New or Revised Item

This Manual Change Sheet contains important information for correcting manual errors and for adapting the manual to instruments which contain modifications made after the printing of the manual.

CHANGE 2 for Instruments With REV C A50 Assemblies

Figure 1. Circuit addition to A508, CLOCK N.

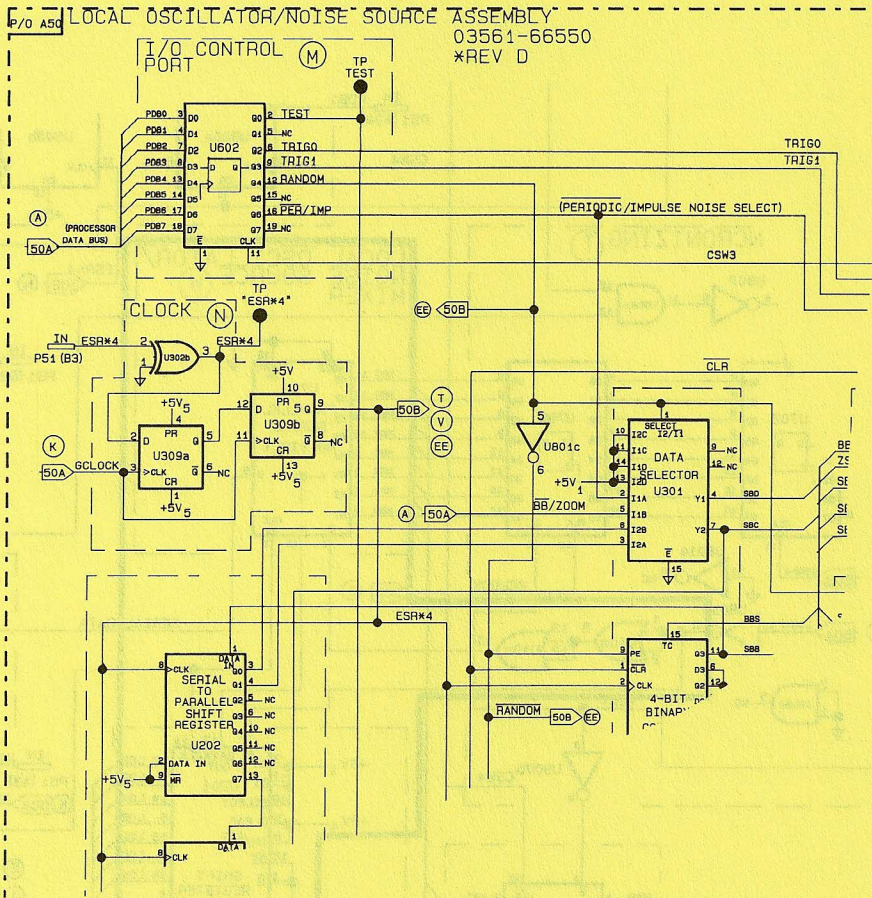
Page 7-149/7-150, A50B Schematic, CLOCK N. Add U309 circuits in Figure 1 to the A50B Schematic.

Figure 2. Circuit addition to A508, Local Oscillator/Noise Source Mixer W and Local Oscillator Interface X

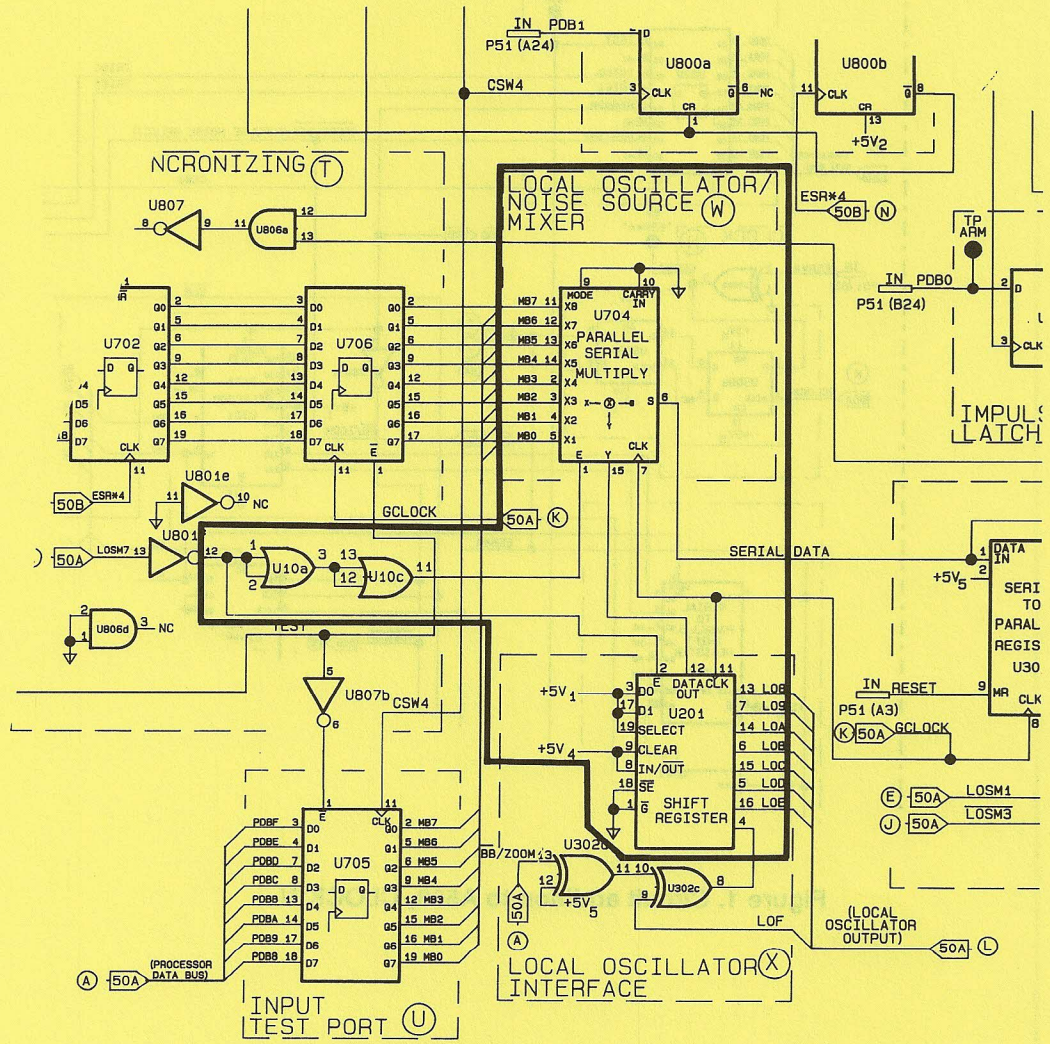
Page 7-179/7-150, Schematic A50b, LOCAL OSCILLATOR/NOISE SOURCE MIXER W/LOCAL OSCILLATOR INTERFACE X. Add 2 OR gates from U10 between U201(2) and U704(1) as illustrated in figure 2.
